Date	19/05/2016
Number	0682
Pages	8

### TECHNICAL INFORMATION

MODEL	MT09 / MT09A / FZ09 / MT09TRA / FJ09
SUBJECT	CAM CHAIN TENSIONER (CCT) NOISE

## **FACTORY SOLUTION:**

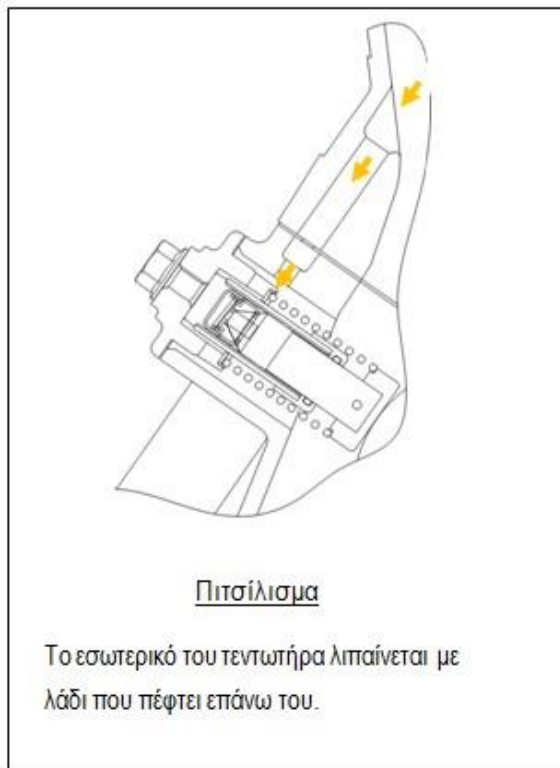
The contact between the threaded half nut and retaining surface damaged due to insufficient lubrication. The wear results in reduced friction and move the half-nut. As a result, the tensioner is not held taut and the chain oscillates causing noise.

The way lubrication changed from splashing in pressure lubrication.

### SOLUTION FOR VEHICLES ALREADY ON THE ROAD:

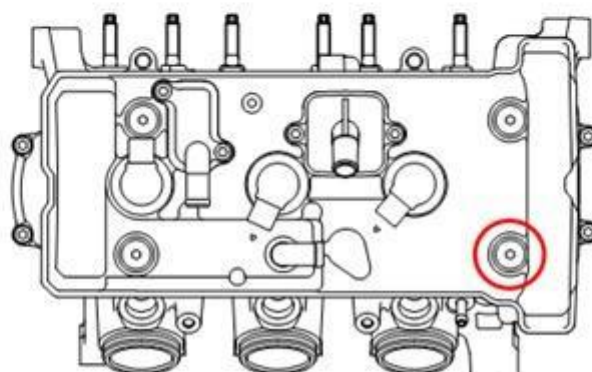
The existing oil flow is changed in a way that improves the lubrication of the tensioner.

One of the head cap screws is replaced with a bearing inner oil passage to convey oil from the easel camshaft on the roller.

In case of a problem, replace the tensioner and place all the parts of improved kit.

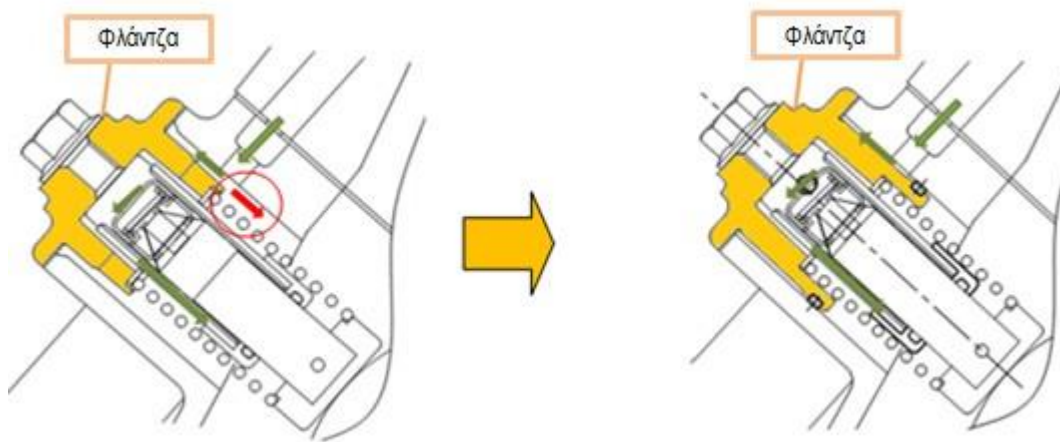
To effectively lubricated inside the tensioner, the inner flange of the tensioner grew to drive more oil in disputed wear point of the tensioner.

End gap

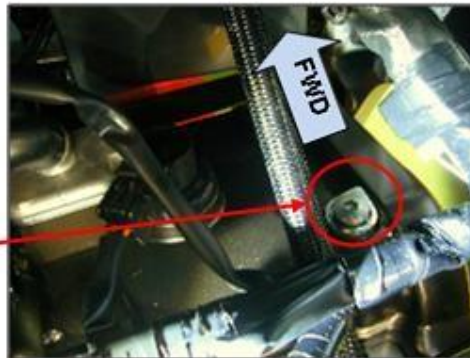
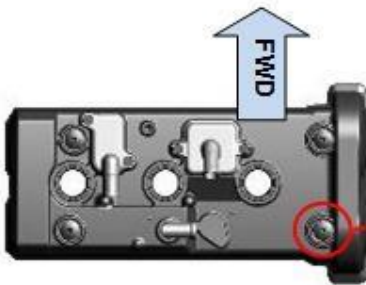
Τοποθετήστε τον τεντωτήρα με το άνοιγμα του δαχτυλιδιού προς την κάτω πλευρά του κινητήρα.

Ίσως δυσκολευτείτε στην τοποθέτηση του τεντωτήρα λόγω ανοχών ανά περίπτωση. Σε αυτήν την περίπτωση σφίξτε από λίγο και εναλλάξ κάθε μία από τις βίδες του τεντωτήρα μέχρι αυτός να πατήσει στον στροφαλοθάλαμο.

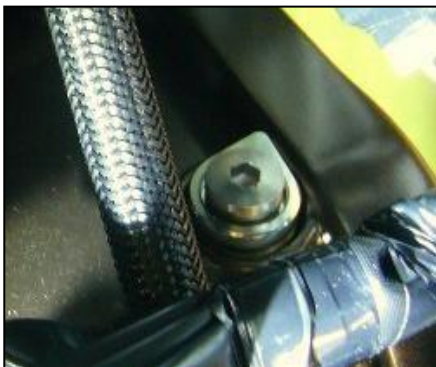
Replace the right screw cap shown in figure with the screw, the flange and the housing provided in the kit. Tighten to 10Nm.

Before tightening the screw, align the casing with the cover, as shown in figure.

**ΣΗΜΕΙΩΣΗ :** Δώστε προσοχή στην τοποθέτηση της θήκης. Εάν δεν ευθυγραμμιστεί σωστά δεν θα περάσει λάδι προς τον τεντωτήρα.

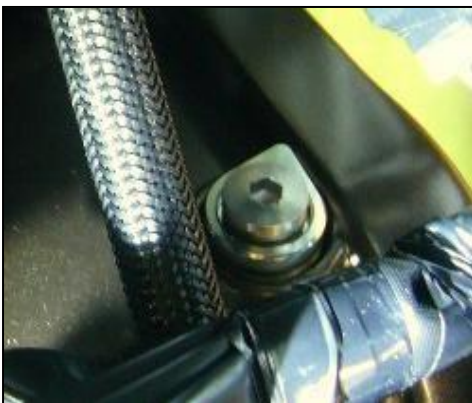
As in the process for kit 1, replace the right screw cap shown in figure with the screw, the flange and the housing provided in the kit. Tighten to 10Nm.

Before tightening the screw, align the casing with the cover, as shown in figure.

**ΣΗΜΕΙΩΣΗ :** Δώστε προσοχή στην τοποθέτηση της θήκης. Εάν δεν ευθυγραμμιστεί σωστά δεν θα περάσει λάδι προς τον τεντωτήρα
